# Rufus 2.0 - Block 19

## Purpose of Recommendation Meeting #3

FIGURE 1A

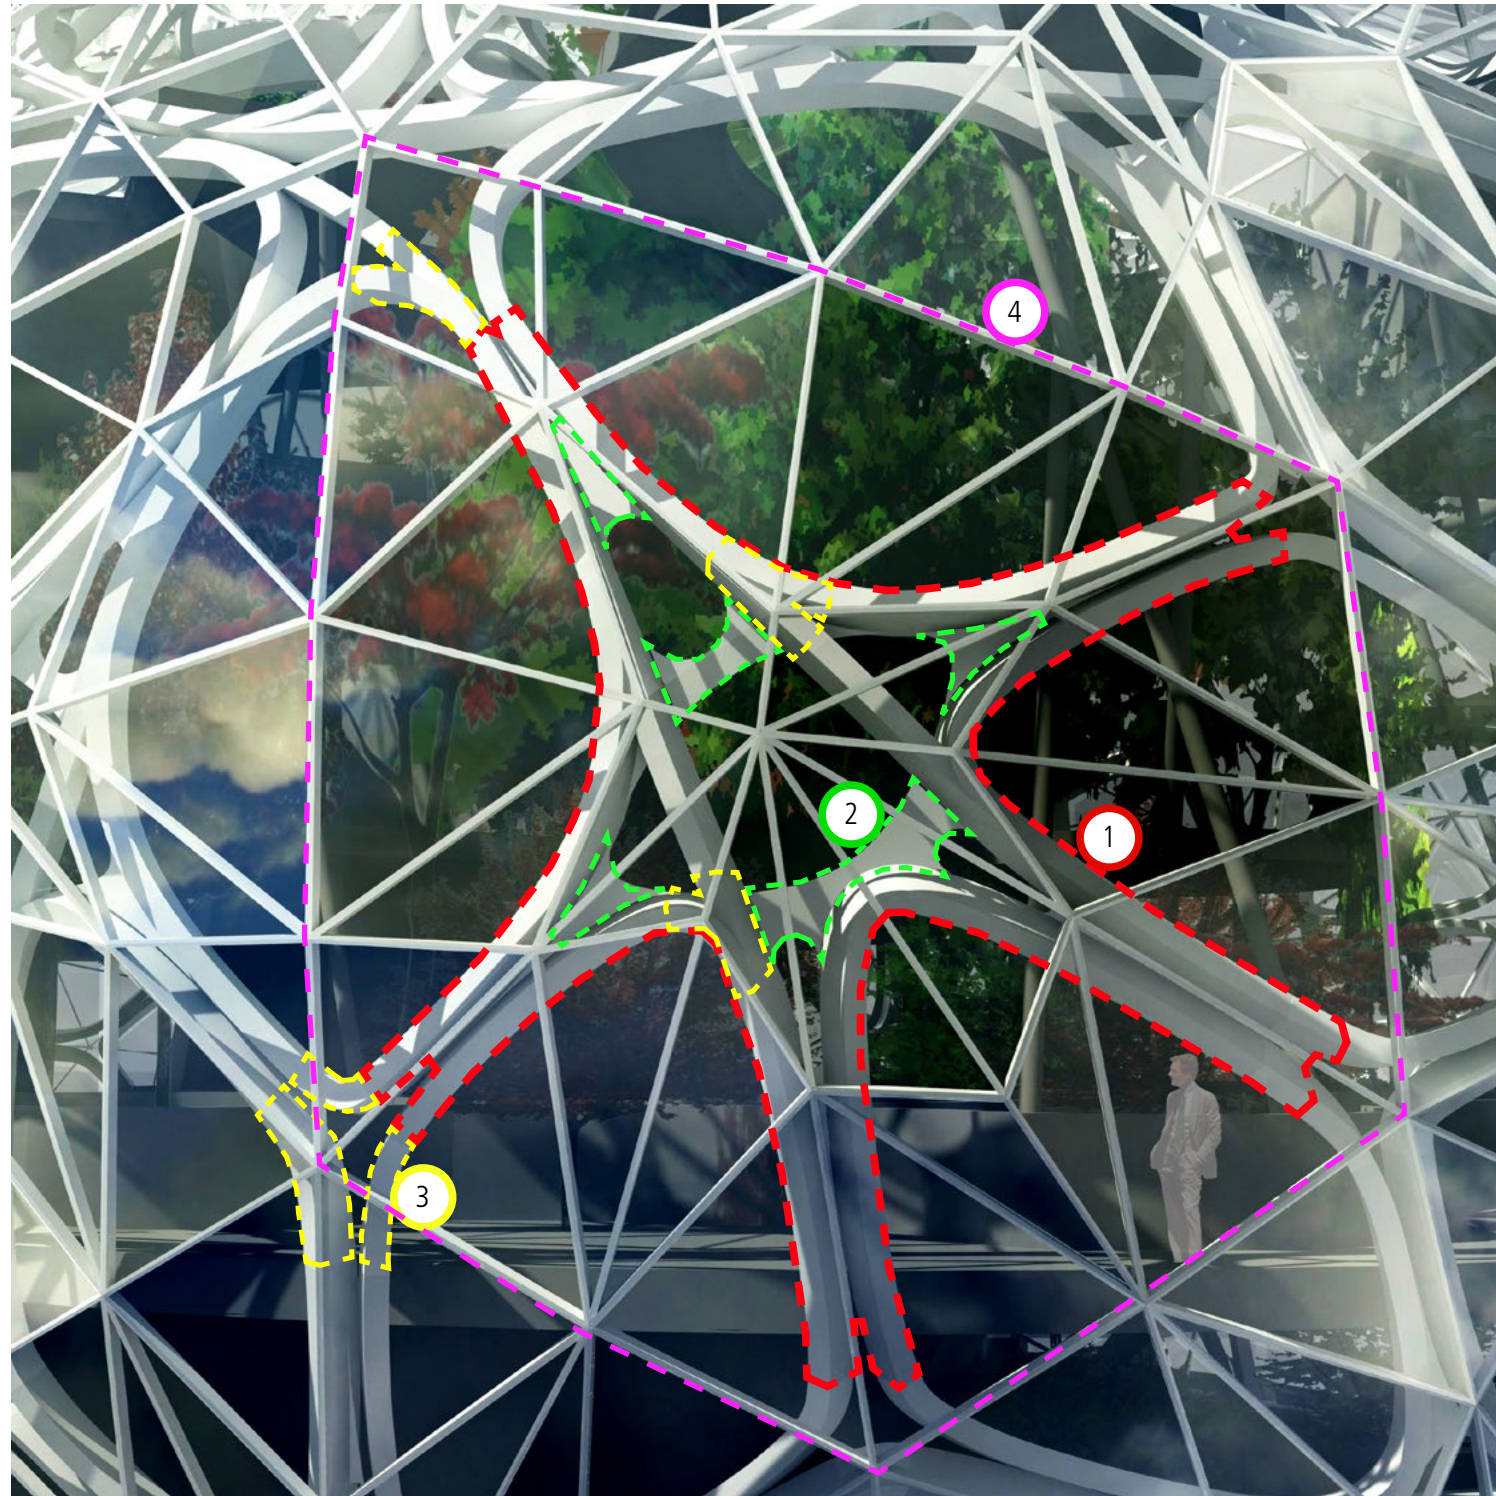
a. The Board agreed that the evolved form of the spheres included a very interesting and innovative structural system. The Board noted the juxtaposition of the transparent, flat glass panel glazing system of the skin with the interior freestanding structural system. (B-4, C-2)

b. The Board encouraged exploration of the structural members using varying depths to further express the organic design concept. (B-4, C-2)

The structural system of the Spheres has continued to evolve to be both more elegant and efficient. The integration of the structural and glazing system maintains a faceted enclosure supported by a freestanding interior modular structure. See Figure 1A which outlines the current catalan modules. Page 1 and Figure 1C depict the updated Spheres skin in an aerial view. The design of the Catalan will continue to evolve and the actual design of the structural module may be varied.

By combining cast steel, rolled sections, and flat plate steel the current catalan structural module maximizes the various benefits of each manufacturing type. Cast members seen in Figure 1A make up the geometrically complex nodes which join the more consistently shaped rolled steel sections. Plate steel forms the rigid webbing in each module. The evolution of the catalan module is shown in Figures 1D & E. When compared to the previously presented design, the overall effect of the current catalan module is visually lighter, and geometrically organic and sculptural.

FIGURE 1F

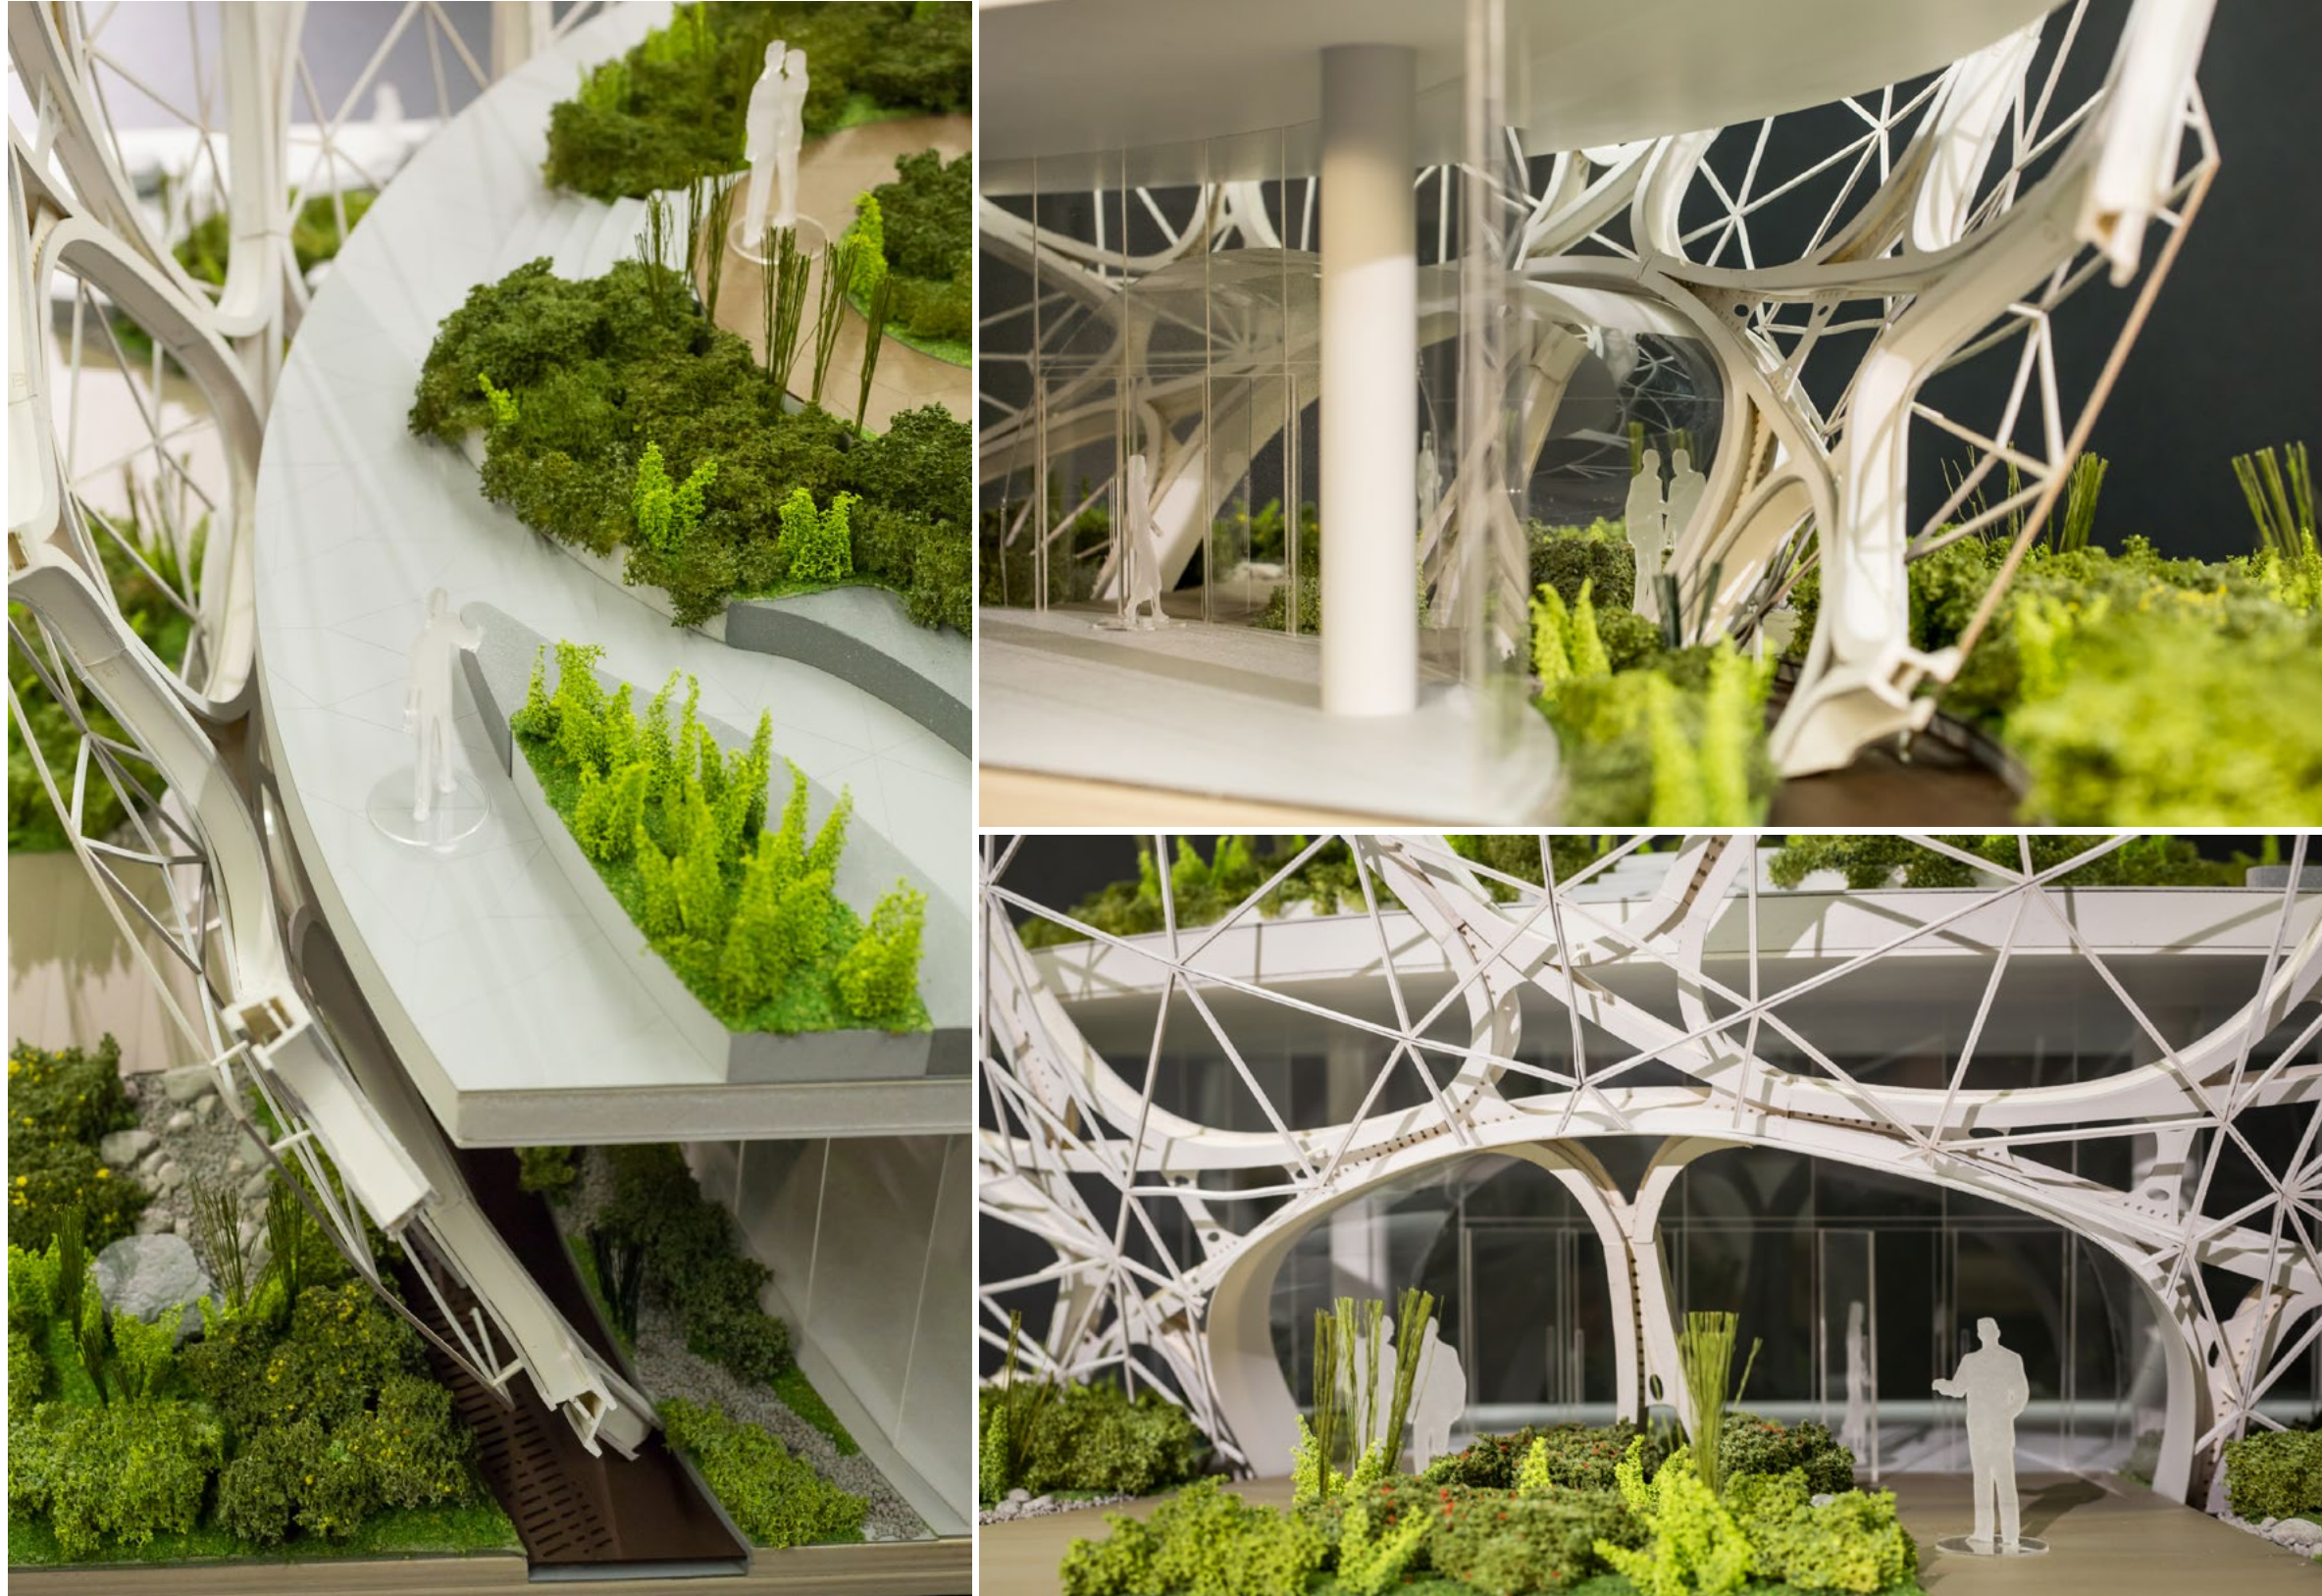
c. The Board encouraged the building to be as energy efficient as possible in an effort to support and enhance the bold innovative architecture.

Efficient building systems are being incorporated throughout the Spheres in order to ensure that the targeted LEED Gold rating is achieved for Block 19. See Figure 1F for samples of materials being proposed in the design.

FIGURE 2B

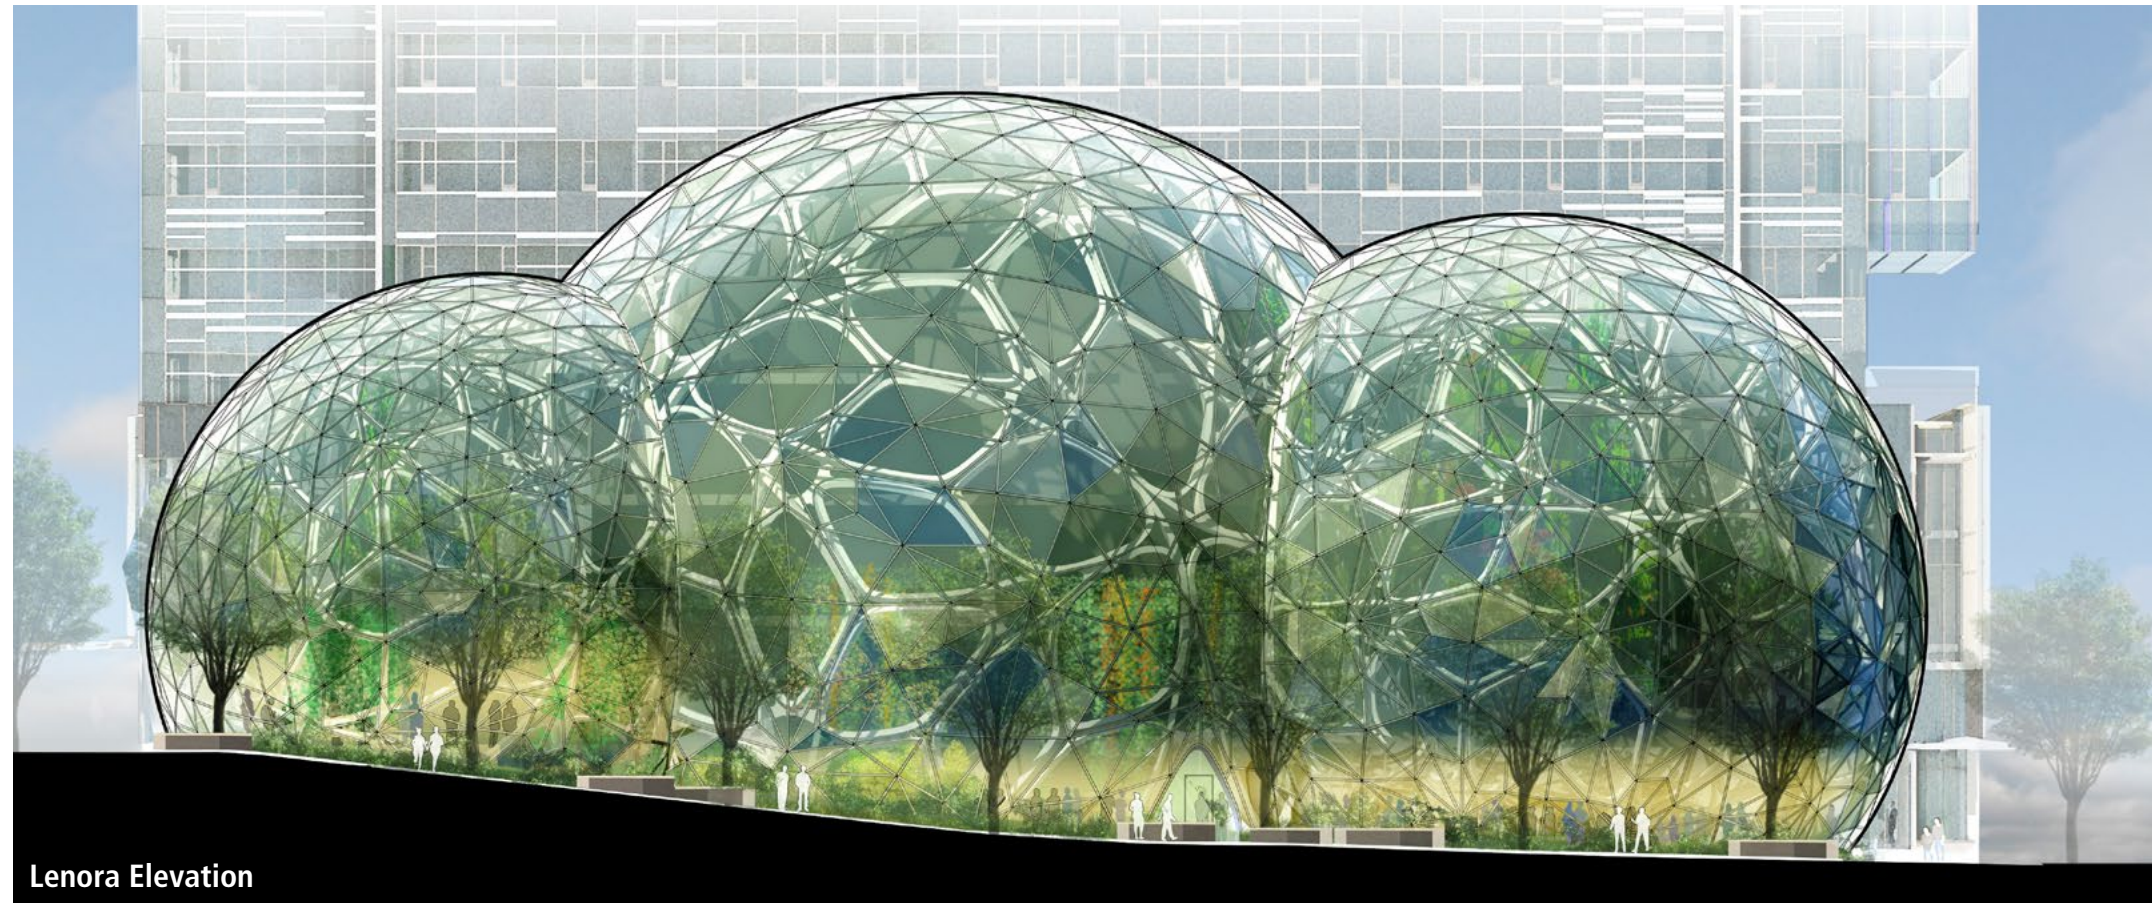
c. The Board was pleased with the seating opportunities provided along Lenora to provide pocket spaces for moments of pause and further developing the concept of the object within a park with the landscaping and seating wrapping around to the Lenora side of the block. (A-1, B-1)

Further development of the landscape plan around the Spheres, including along Lenora, is shown in Figure 2B. Note enhancement of outdoor seating opportunities.
